Technical Service Bulletin

Notice of wiper blade replacement requirement

This bulletin describes a required wiper blade replacement on the specific 2014 and 2015 model year Newmar coaches listed in this bulletin

To Remove Frameless Blade

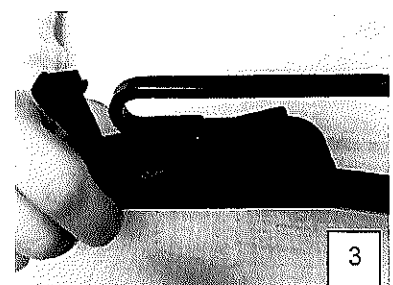
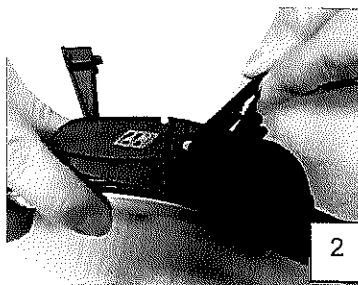
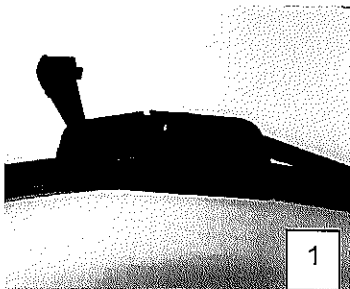
Frameless style windshield wiper blades P/N 302-2320 supplied on designated coaches may separate from wiper arm connector when wiper system is operated at the high speed setting.

Frameless wiper blades P/N 302-2320 MUST be immediately replaced with framed wiper blades P/N 302-1320 supplied with this service bulletin.

1. Remove frameless blade 302-2320 from wiper arm, driver and passenger side.
DISPOSE OF REMOVED BLADES

1. Lift plastic cover to expose arm hook.
2. Squeeze plastic clip
3. Push blade back to remove from arm

To Install Framed Blade

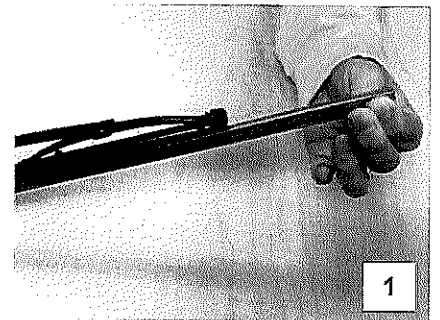
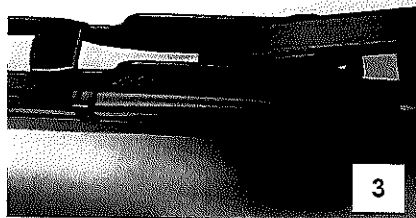
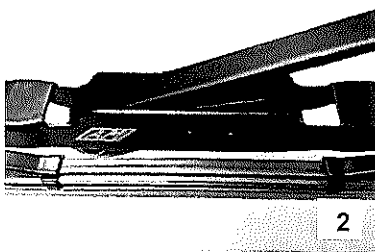
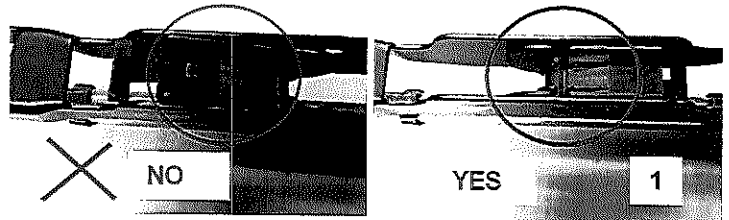
2. Install framed blade 302-1320 on wiper arm, driver and passenger side.

- 1 Orient the plastic retainer to the locking nib faces the down towards the glass
- 2 Slide hook of arm around blade plastic retainer
- 3 "CLICK" blade into place. Test to insure blades has locked onto the hook securely
- 4 Remove protective from rubber part of blade
